14 January 2026

Subject: Baldon Wind Farm (SSD-40138508) Response to Request for Amendment Letter

Baldon WIND FARM

Figure 2-1: Amended Project Layout

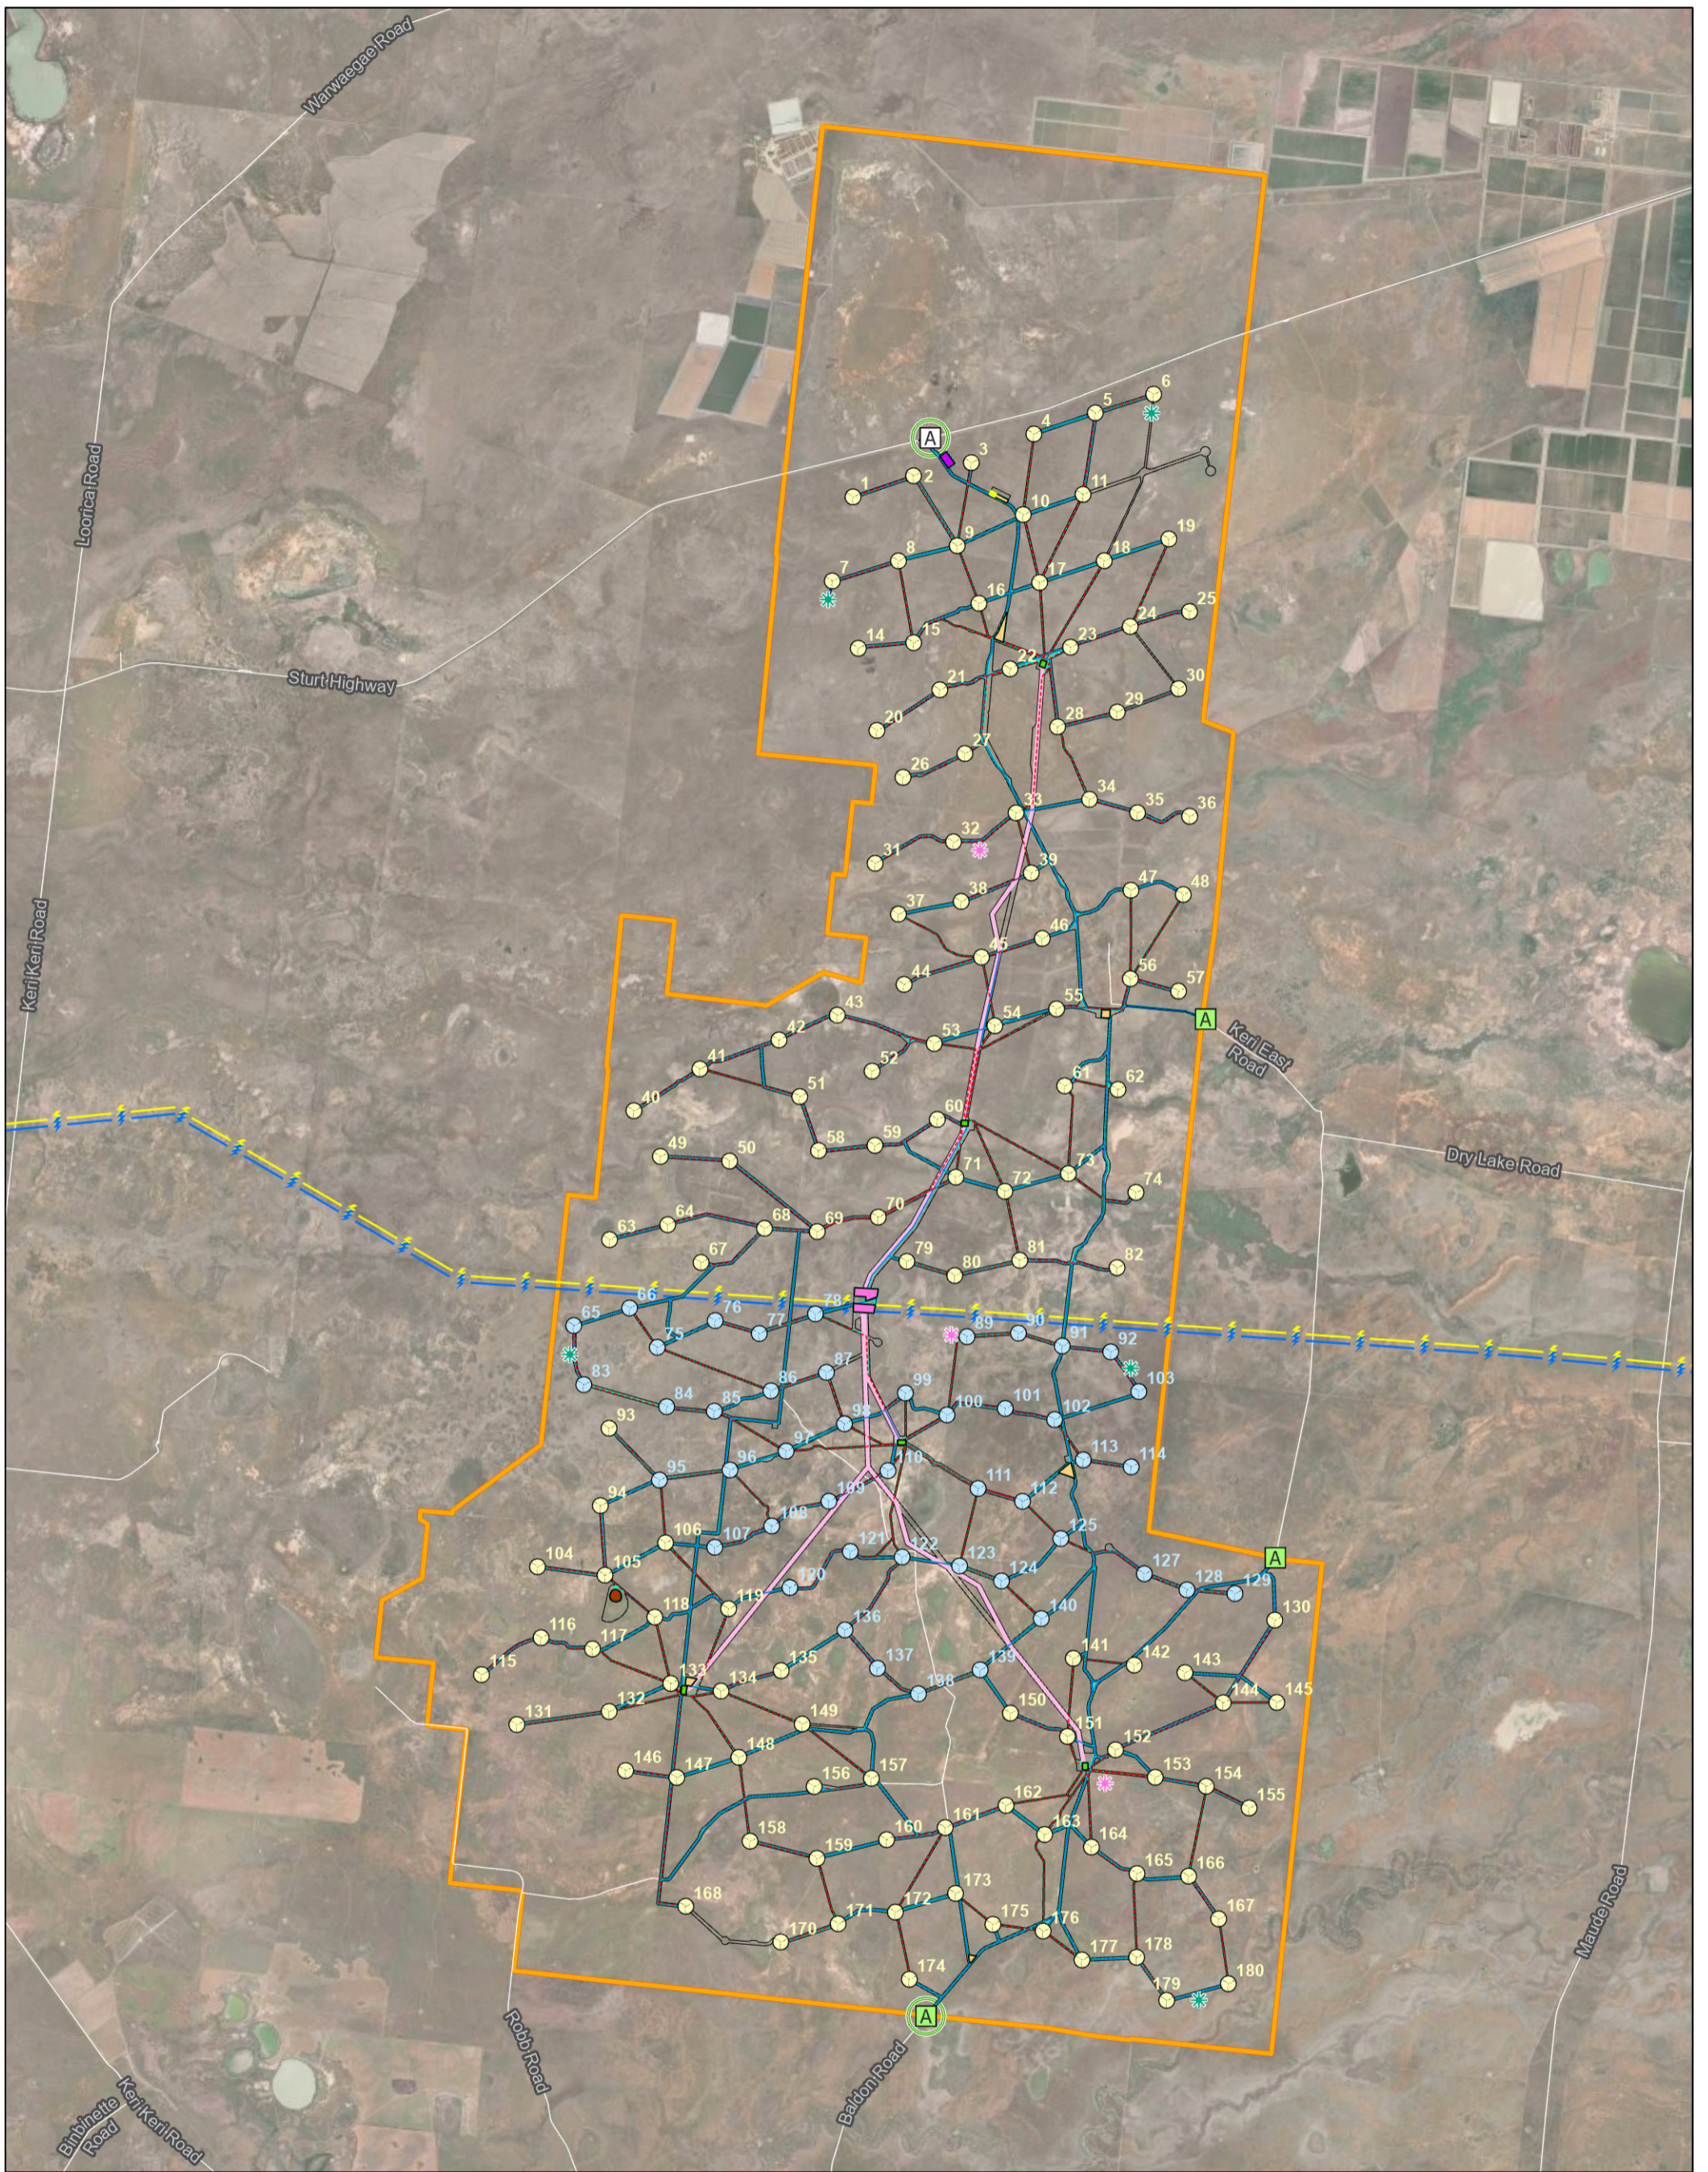
- Removal of five wind turbine generators (WTGs) (numbers 12, 13, 88, 126 and 169) from the proposed Project design to avoid potential flooding and biodiversity impacts. Refer to Figure 1 for the revised layout of the Amended Project. The refined Project comprises up to 175 wind turbines, with each WTG having a maximum tip height of up to 300 m. It is likely that the development will be staged with Stage 1 involving up to 46 turbines and Stage 2 a further 129 turbines
- Removal of several access tracks and reduction of cabling to minimise fragmentation of Plains

Provided in **Figure 2-1** is the project layout incorporating the amendments identified in **Table 2-1**

Figure 2-2: General Layout Modifications

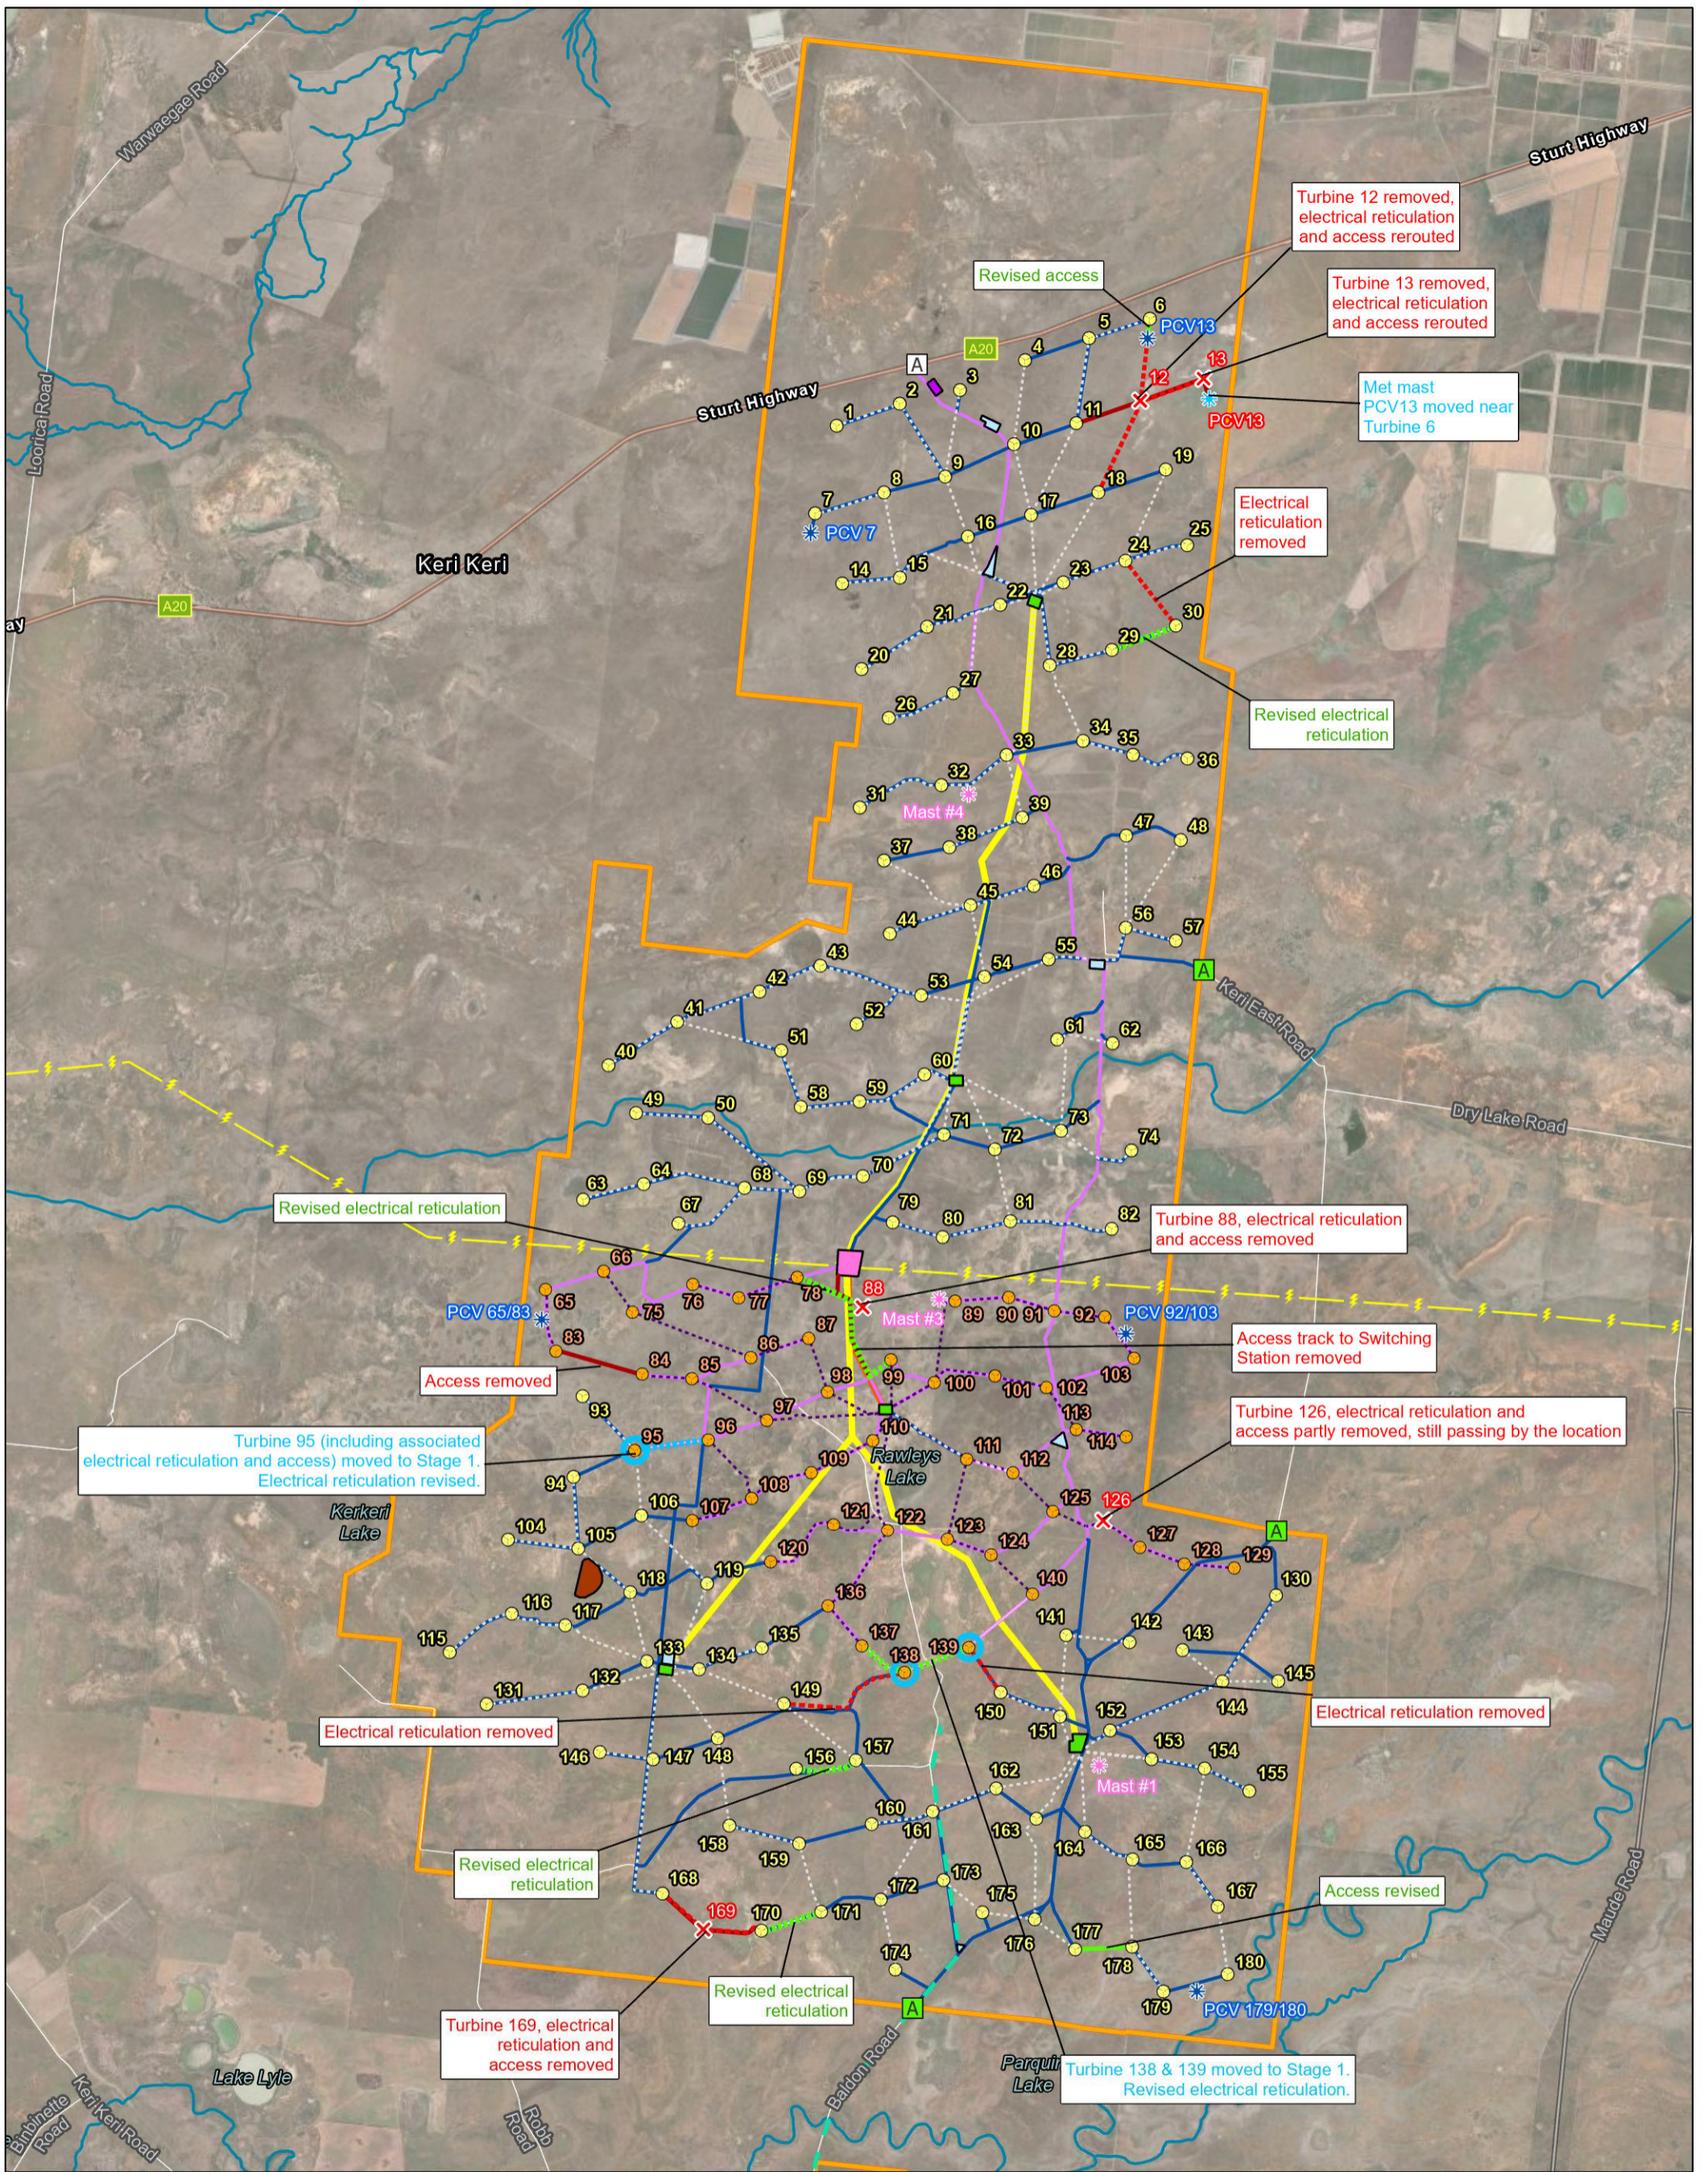
Figure 2-2 indicates where layout modifications have been undertaken as summarised in **Table 2-1**.

Figure 2-3: Amended Project Road Upgrades

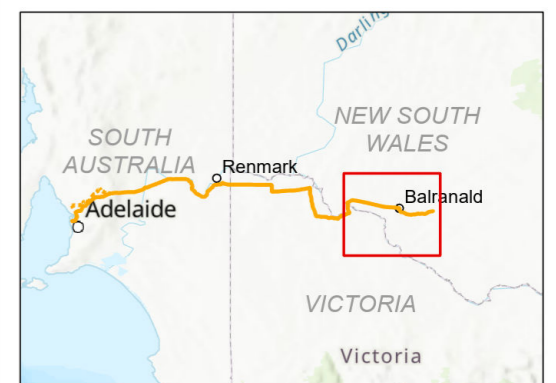
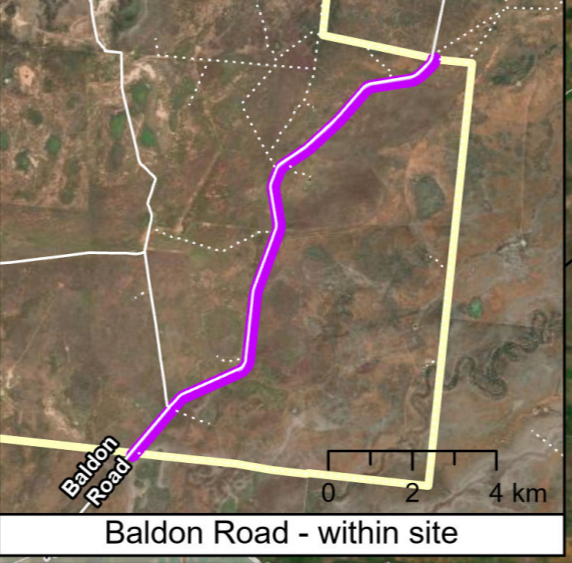
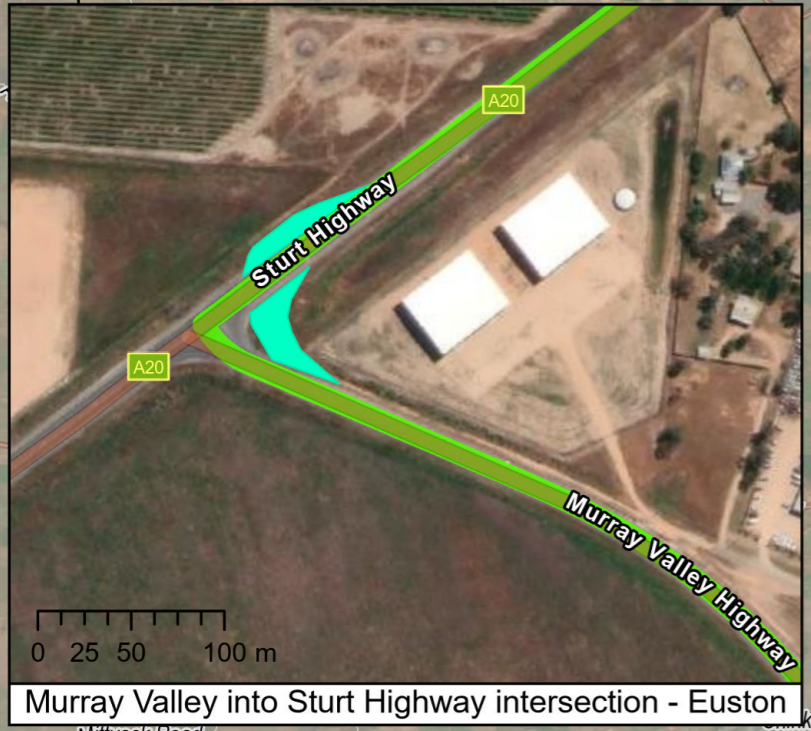
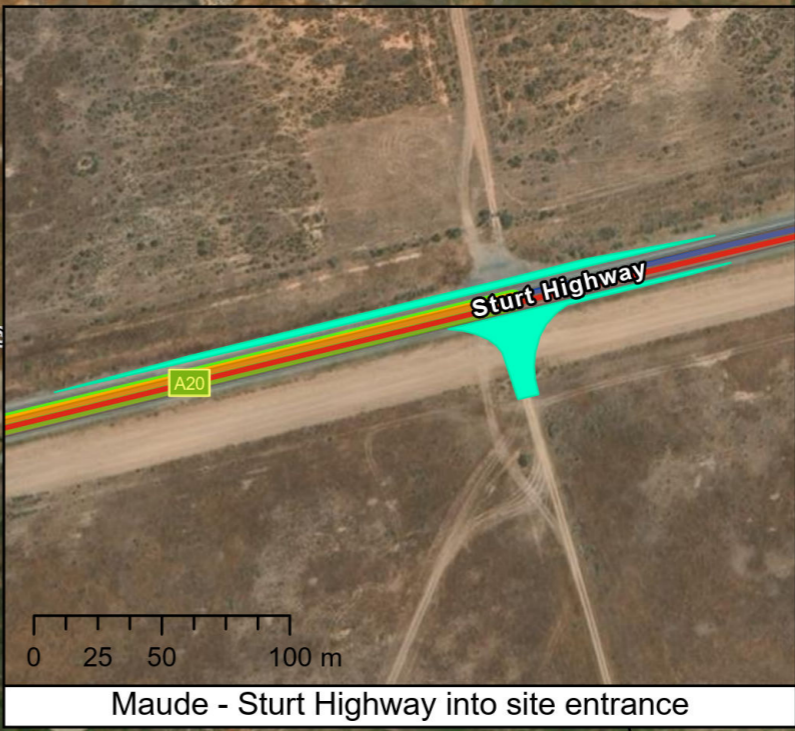
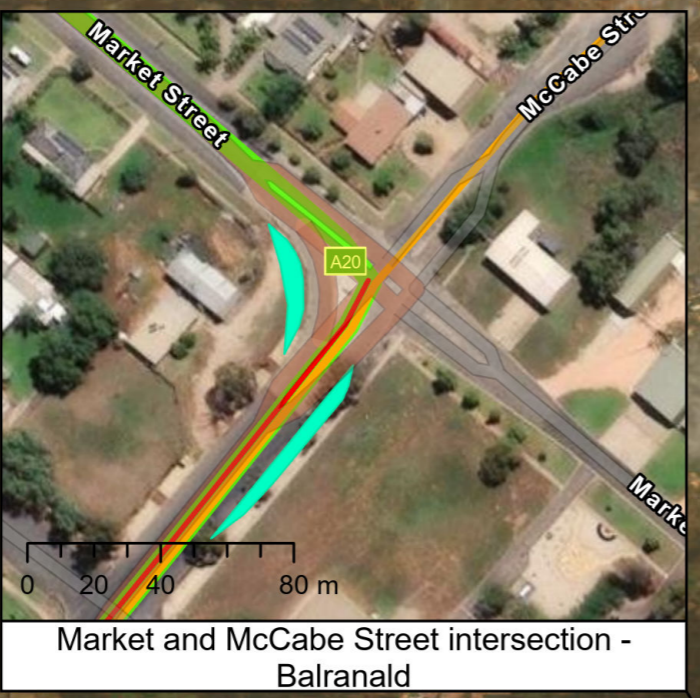
Provided in **Figure 2-3** is a summary of all the proposed road upgrades for the BWF Project. In total there are five road upgrades within NSW which have been included as part of the assessments prepared for the Project. Each location and areas proposed for upgrade are provided in **Figure 2-3** and include:

Sections of Keri East Road and Baldon Road, located within the Project Area are to be upgraded to allow for construction vehicles use. With reference to Baldon Road the upgrade is also required to provide for the use of OSOM vehicles.
